Access Compliance Report

Public Rights-of-Way (Curb Ramps)

Intersection ID: 54302	Main Street: PROVIDENCE_FARM_LN	Cross Street: ARDREY_KELL_RD	Location: SW
ADA ID: 915131C8C21D	Ramp Type: Directional1	Initial Pass/Fail: Pass	Overall Compliance: No
Severity Score: 0			
Codes/Mitigation Info/Possible Solution		Field Measurements/Component Compliance

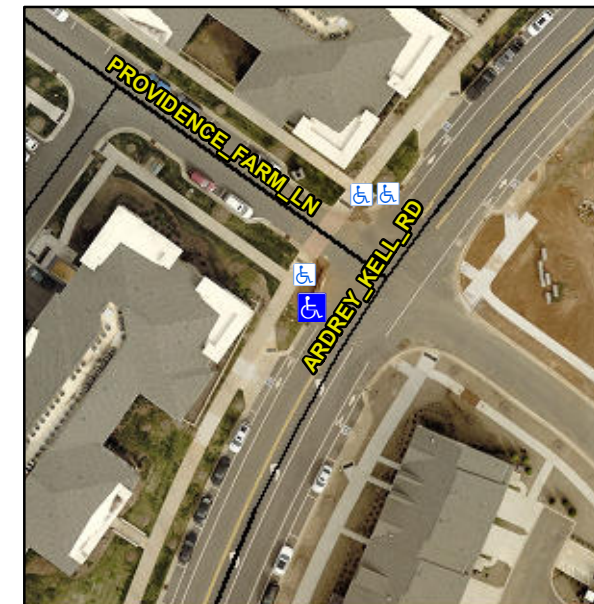
R304.5.2

Compliance	Description	Data	Compliance	Description	Data
N/A	Ramp Length (in)	110.0	No	Grade Break?	No
Yes	Ramp Width (in)	70.0	N/A	Grade Break Slope (%)	5.2
Yes	Ramp Slope (%)	5.1	N/A	Grade Break XSlope (%)	1.6
Yes	Ramp XSlope (%)	0.5			
Yes	Flare Type LT	N/A	Yes	Flare Type RT	N/A
N/A	Flare Slope LT (%)	N/A	N/A	Flare Slope RT (%)	N/A
N/A	Flare Traversable LT?	No	N/A	Flare Traversable RT?	No
Yes	Landing Length (in)	95.0	Yes	DWS Provided?	Yes
Yes	Landing Width (in)	70.0	Yes	DWS Contrast?	Yes
Yes	Landing Slope (%)	1.6	Yes	DWS Length (in)	24.0
Yes	Landing X Slope (%)	1.0	Yes	DWS Full Width?	Yes
N/A	Landing Curb? (Y/N)	N/A	Yes	DWS Offset LT (in)	36.0
N/A	Shared Landing?	Yes	Yes	DWS Offset RT (in)	2.0
Yes	Gutter Ponding?	No	Yes	Gutter Slope (%)	1.2
Yes	Gutter Lip Ht (in)	0.0	Yes	Gutter X Slope (%)	1.7
N/A	Painted X Walk1?	No		Road Slope (%)	1.2
	X Walk 1 Direction	To SE		Road X Slope (%)	1.9
	X Walk 1 Width (in)	N/A		Clear Space?	Yes

X Walk 1 Slope (%)	1.2	N/A	Clear Space to XWalk (in)	N/A
	X Walk 1 X Slope (%)	1.9	Yes	Storm Grate/Utility Hazard?	No
N/A	Ramp inside XWalk1?	N/A		Storm Grate/Utility Type	
Yes	Any Obstructions?	No			N/A
	Obstruction Type		Yes	Surface Condition? (G/P)	Good
			N/A	Curb Slope (%)	7.7

Remove & Replace Entire Ramp.
